Access Compliance Report

Public Rights-of-Way

Intersection ID: 47979	Main Street: SPRINGS_MILL_RD	Cross Street: RAFFIA_RD	Location: SE
ADA ID: 2407432890E3	Ramp Type: PerpDiag	Initial Pass/Fail: Fail	Overall Compliance: No
		Severity Score: 8.75

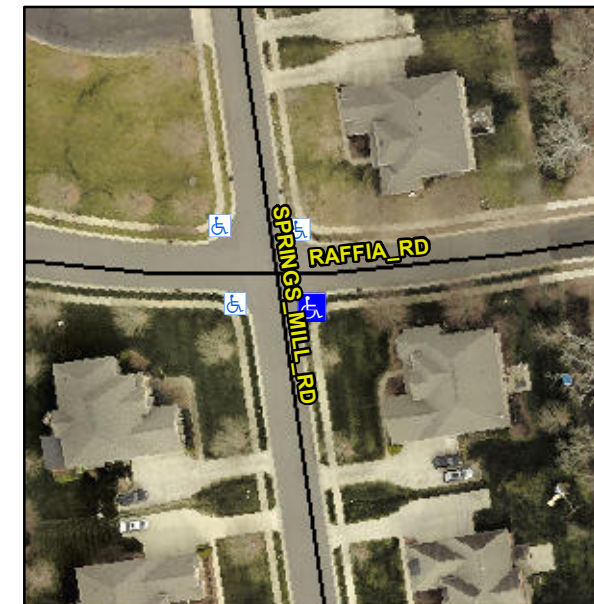
Not Found, R304.5.1

Compliance	Description	Data	Compliance	Description	Data
N/A	Ramp Length (in)	48.0	Yes	Ramp Slope (%)	7.0
No	Ramp Width (in)	46.5	Yes	Ramp XSlope (%)	1.4
N/A	Flare Type LT	N/A	N/A	Flare Type RT	N/A
N/A	Flare Slope LT (%)	N/A	N/A	Flare Slope RT (%)	N/A
N/A	Flare Traversable LT?	N/A	N/A	Flare Traversable RT?	N/A
N/A	Landing Length (in)	N/A	N/A	DWS Provided?	N/A
N/A	Landing Width (in)	N/A	N/A	DWS Contrast?	N/A
N/A	Landing Slope (%)	N/A	N/A	DWS Length (in)	N/A
N/A	Landing X Slope (%)	N/A	N/A	DWS Full Width?	N/A
N/A	Landing Curb? (Y/N)	N/A	N/A	DWS Offset (in)	N/A
N/A	Shared Landing?	N/A			
N/A	Gutter Ponding?	N/A	N/A	Gutter Slope (%)	N/A
N/A	Gutter Lip Ht (in)	N/A	N/A	Gutter X Slope (%)	N/A
N/A	Painted X Walk1?	No	N/A	Painted X Walk2?	No
	X Walk 1 Direction	To N		X Walk 2 Direction	To W
N/A	X Walk 1 Width (in)	N/A	N/A	X Walk 2 Width (in)	N/A
	X Walk 1 Slope (%)	2.2		X Walk 2 Slope (%)	3.0
	X Walk 1 X Slope (%)	2.9		X Walk 2 X Slope (%)	1.3

Remove & Replace Curb Ramp With Two New Directional Ramps or Equivalent.
